Bando Design Ltd. (Extension-2)

10th October 2023

01. Building-6: The structure is a seven (G+6) storied reinforced concrete (RC) building with a semi-basement.

Observation: Building-6 (Utility Building)

Column layout: marking stressed column

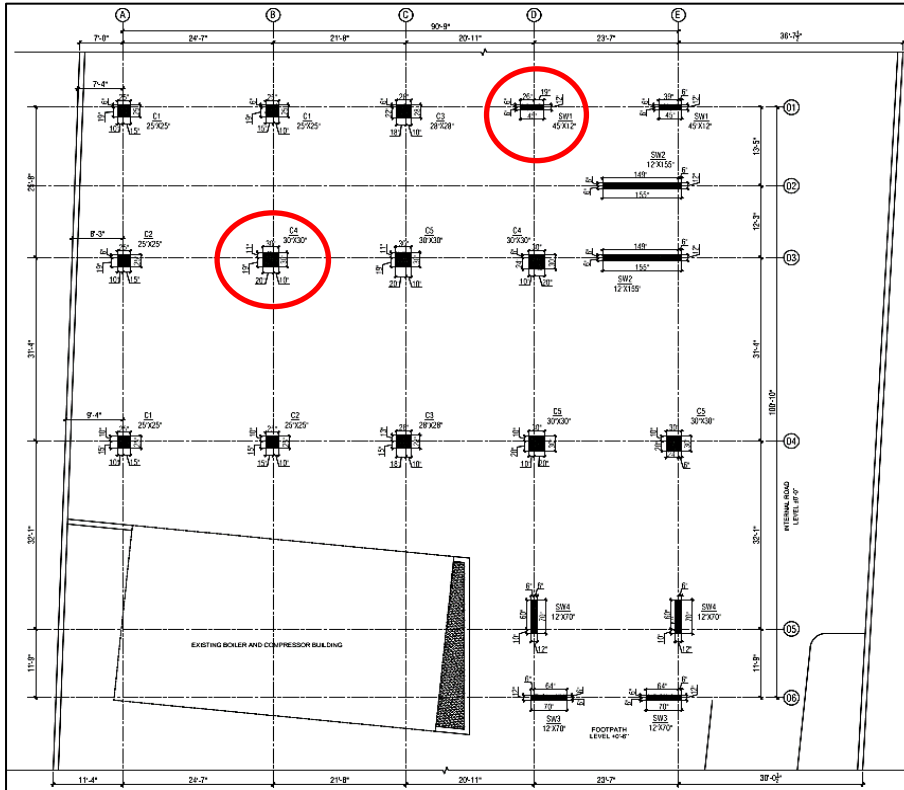
Stress in column exceeds normal design limit

The cursory calculation indicates that stresses in the marked columns are marginally above the normal design limit considering minimum concrete (16.34MPa) for 6 kPa typical floor live load. The source of loading is storage on all typical floors.

The building engineer is required to check the frequency of testing requirements of BNBC for existing concrete cylinder test data. If not justified, verify in-situ concrete strength either by 100mm diameter cores from lower tier columns. Also, review the design, loads and column stresses in the area identified above. Produce and actively manage a loading plan for all floor plates.
